**STATE OF HAWAII
DEPARTMENT OF TRANSPORTATION
AIRPORTS**

**ADDENDUM NO. 1
FOR
CBP FIS RENOVATION
DANIEL K. INOUE INTERNATIONAL AIRPORT
HONOLULU, OAHU, HAWAII
STATE PROJECT NO. CO1433-33**

August 13, 2026

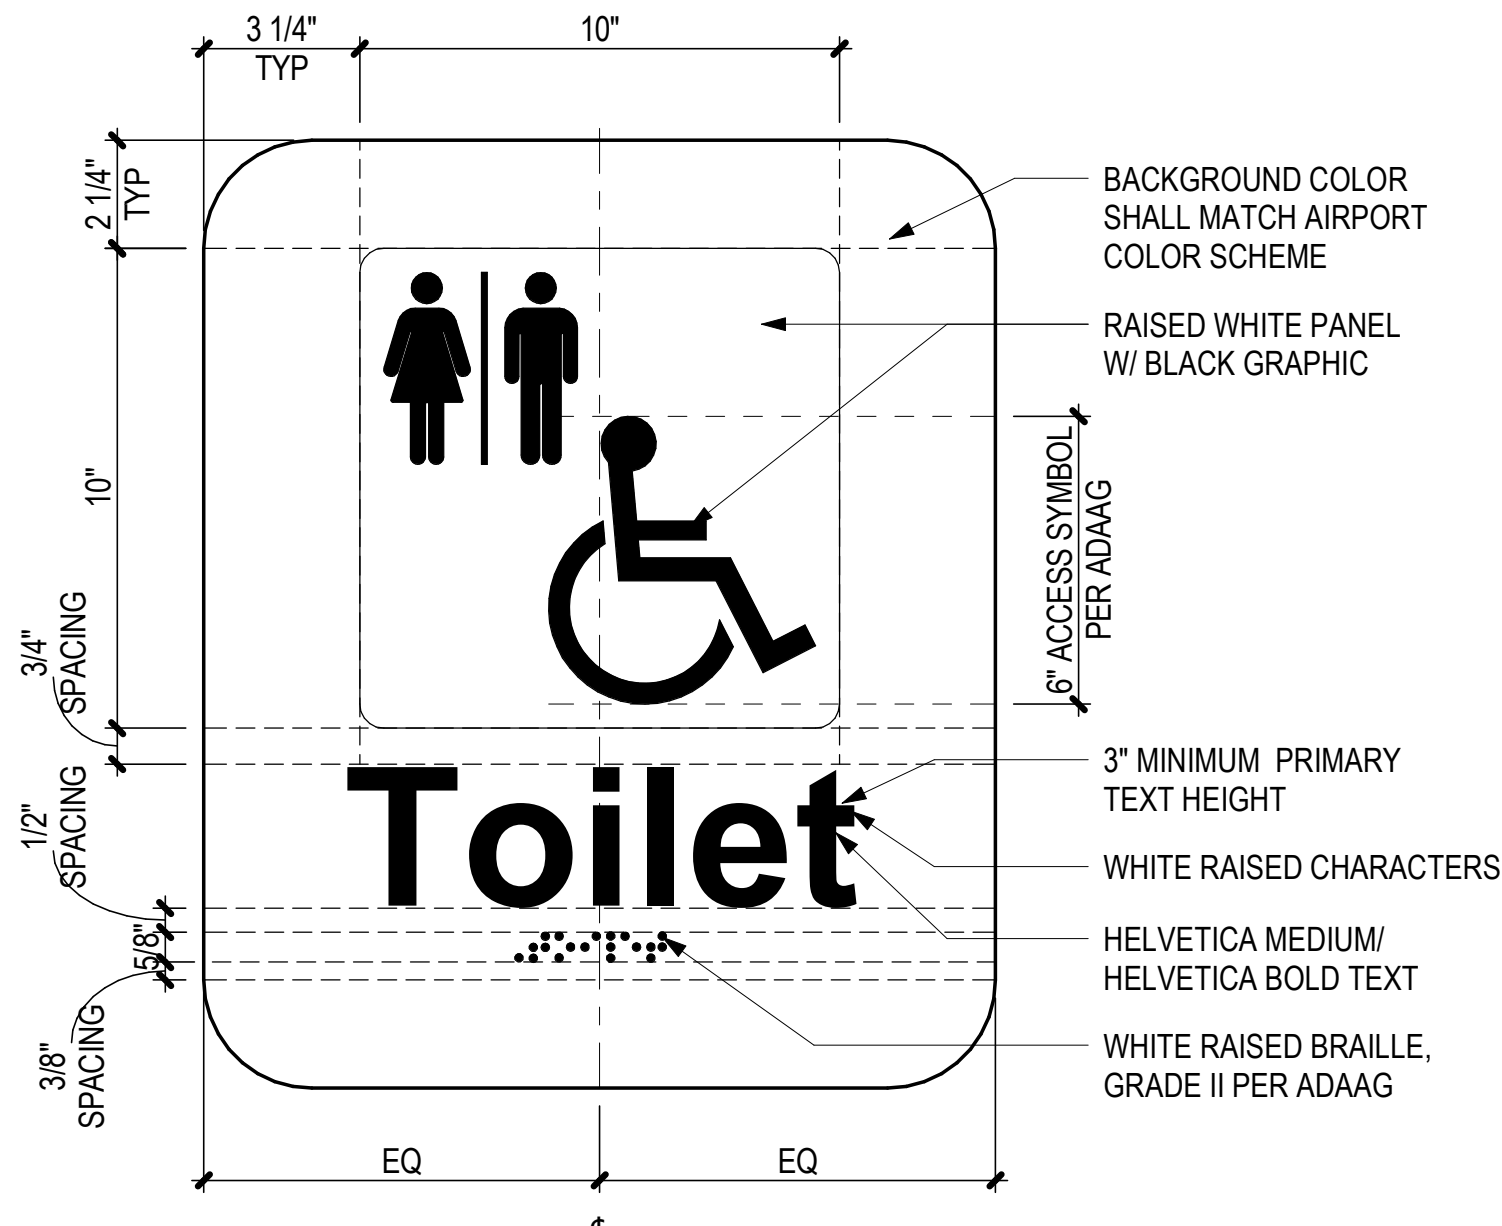
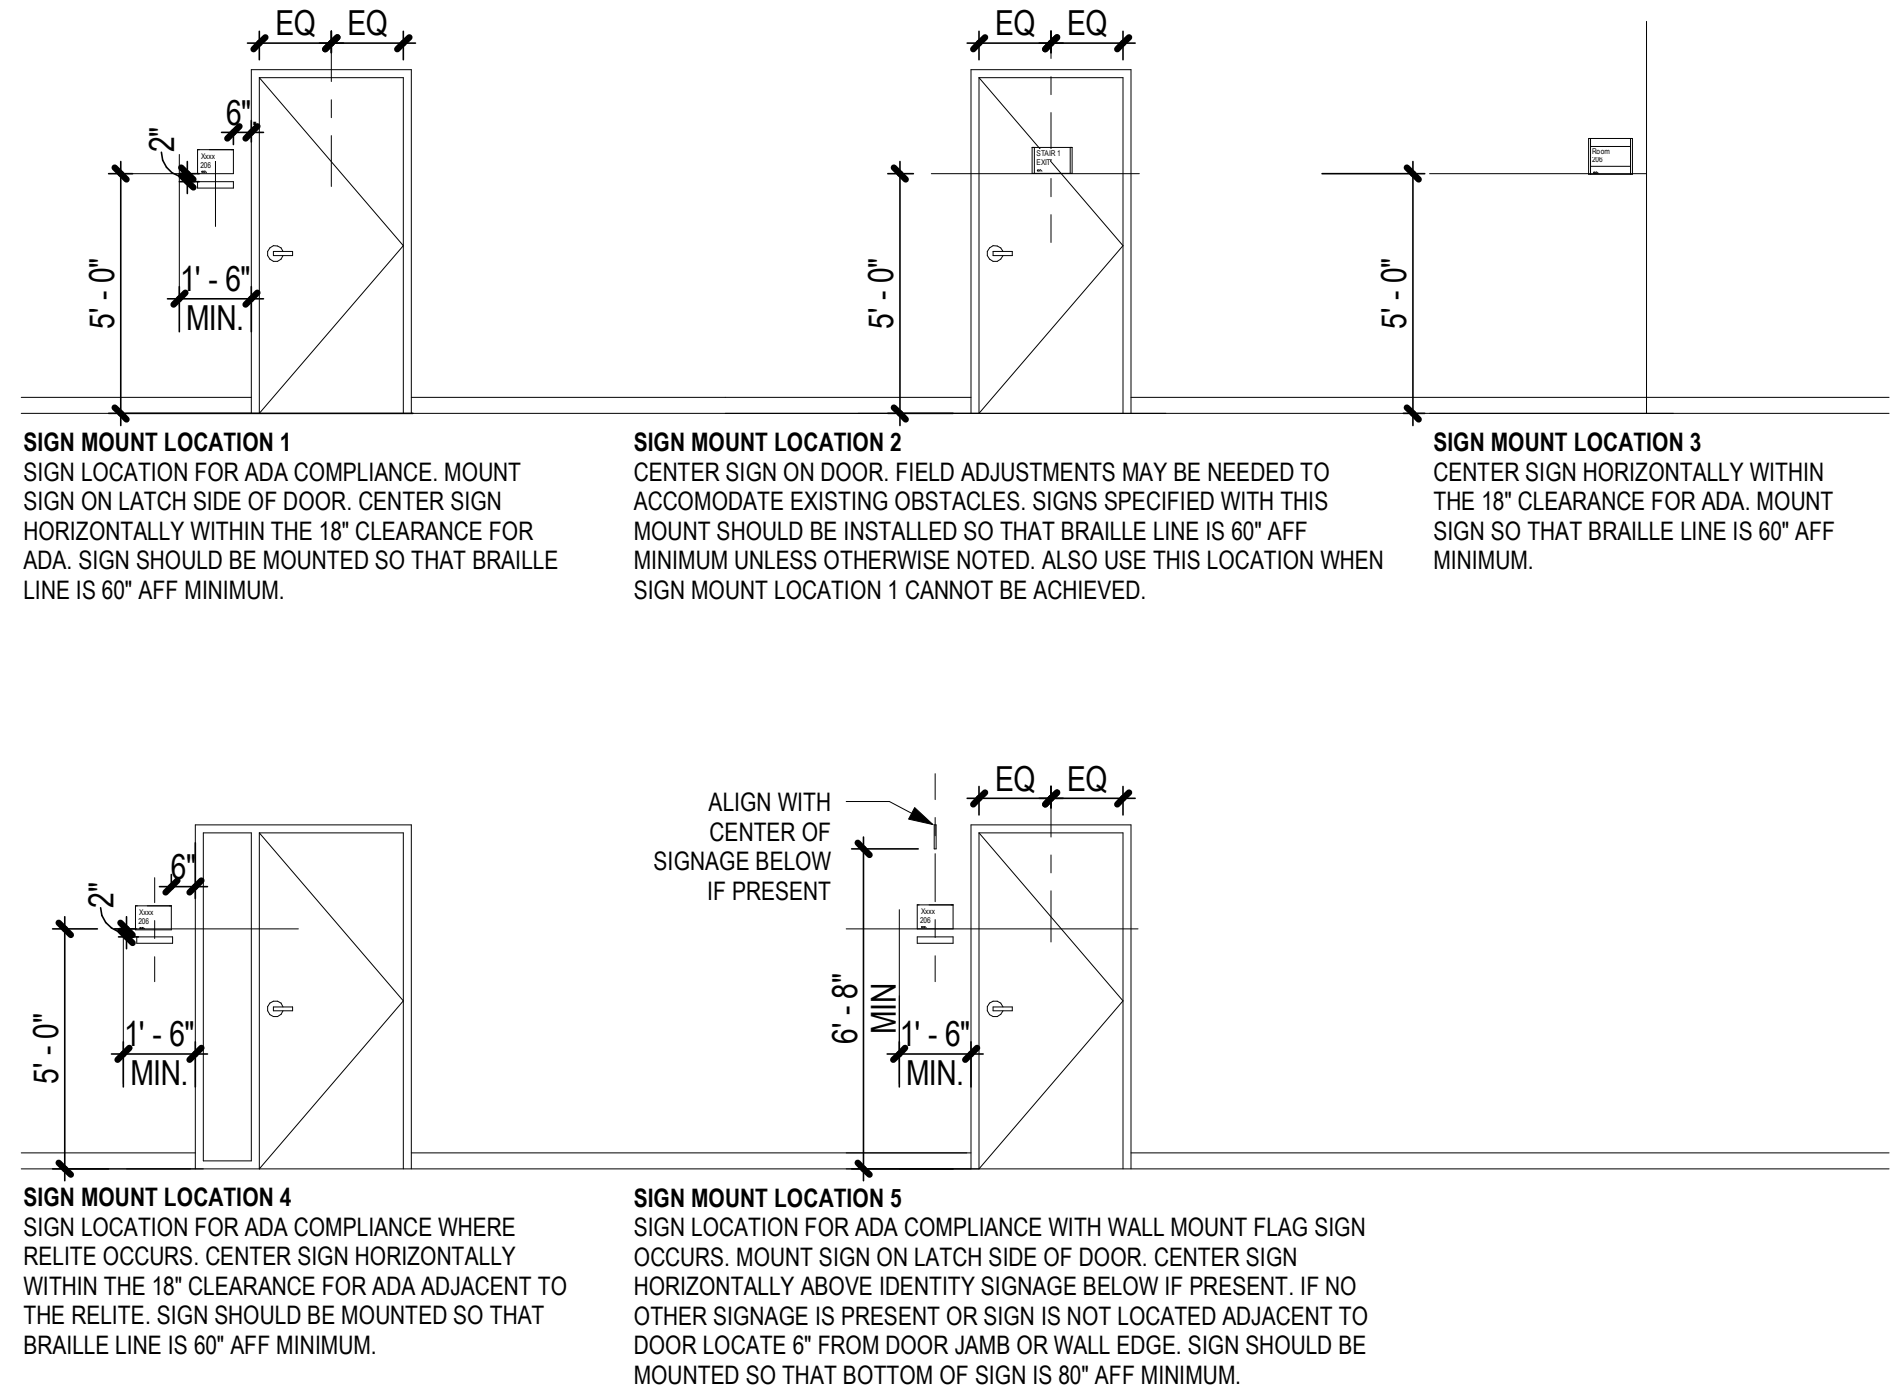
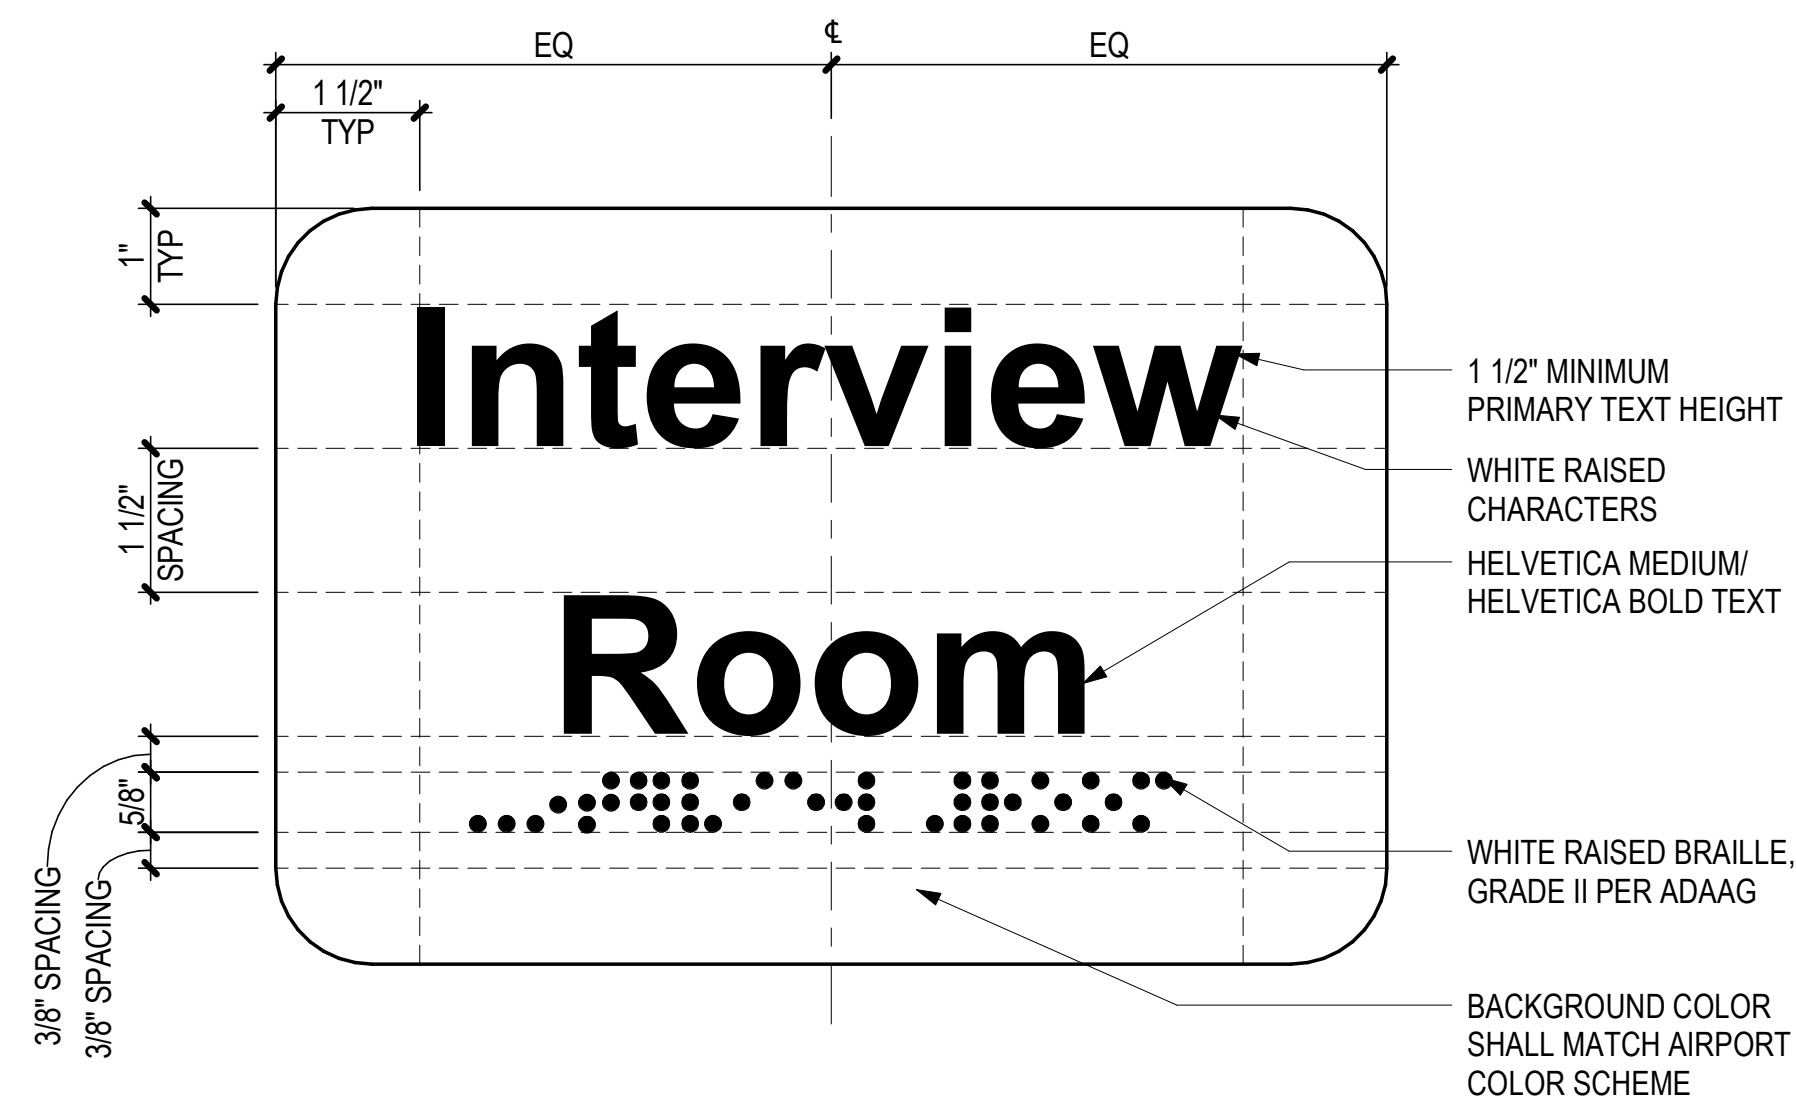
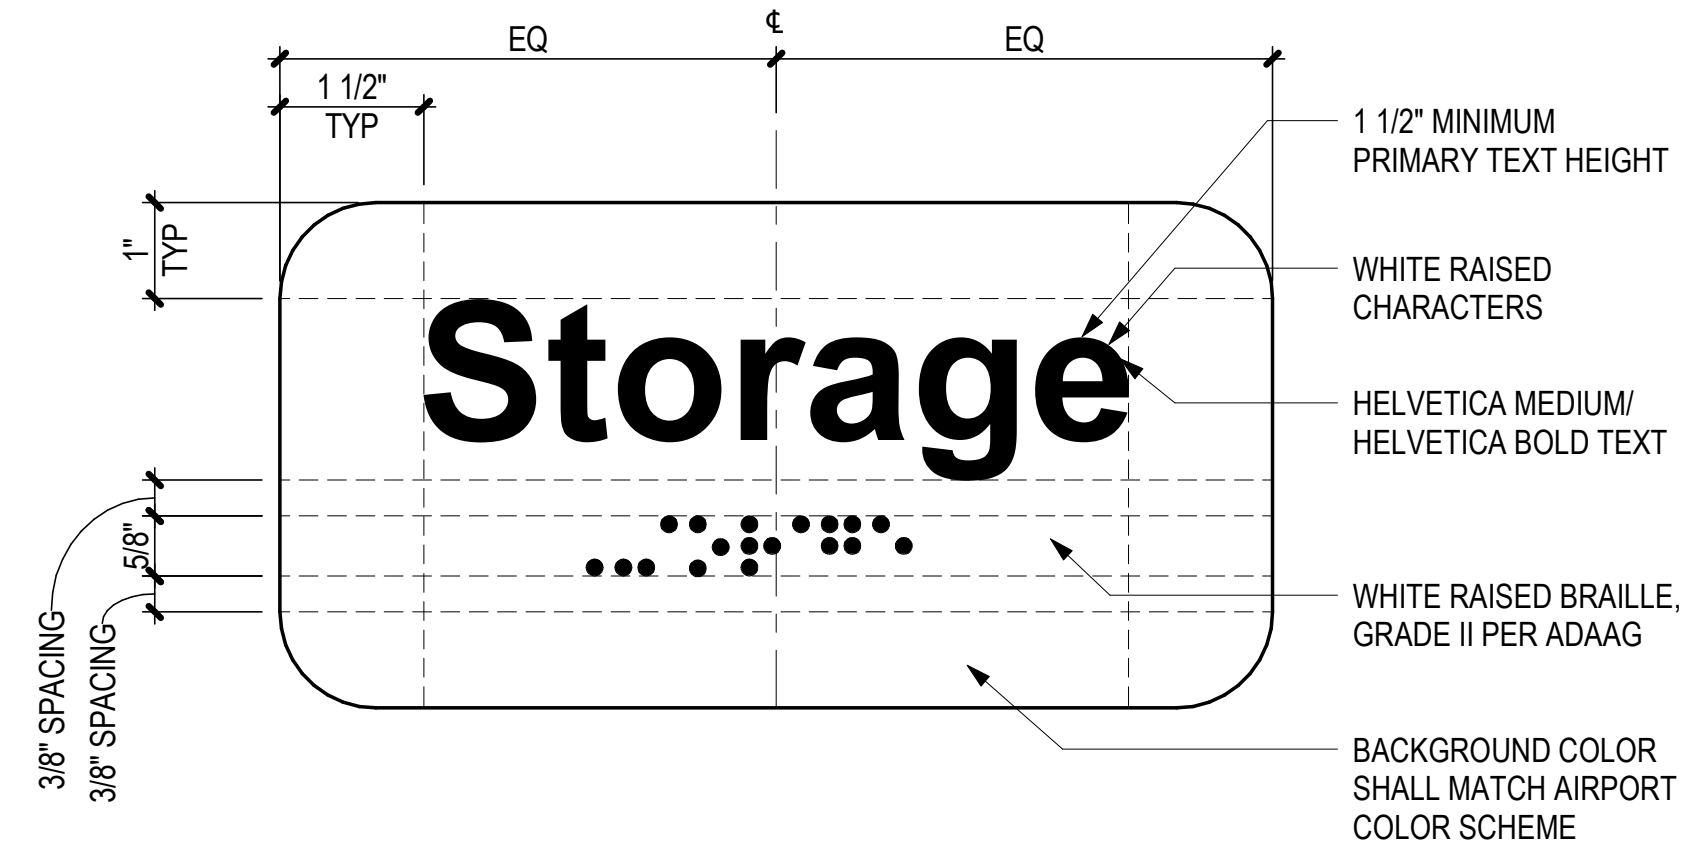
5. **QUESTION:** Please provide drawing for the signage indicated on sheet A-603.

ANSWER: Signage drawings provided with revised A-sheets.
